TECHNICAL BULLETIN

Revised Underscuttle – Revised Mounting Method – Installation Instructions

76-108

MODEL Sedan Range 1990 - 1992 MY

ILLUSTRATION 1

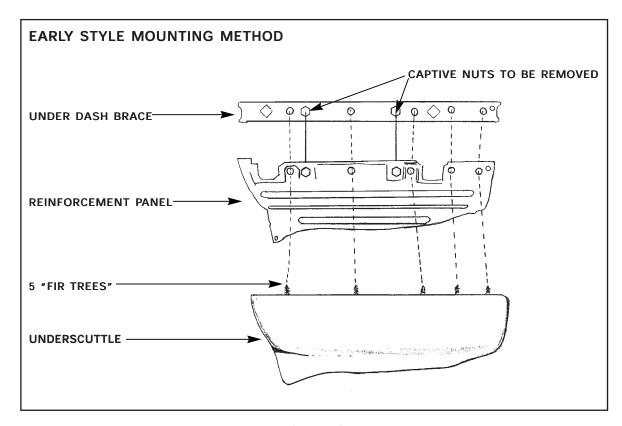
Replacement underscuttle panels have only 3 "fir tree" fasteners and do not fit directly in place of the previous panel with 5 "fir tree" fasteners.

- 2. Remove the reinforcement panel.
- 3. Remove and discard the two captive nuts indicated in Illustration 1.
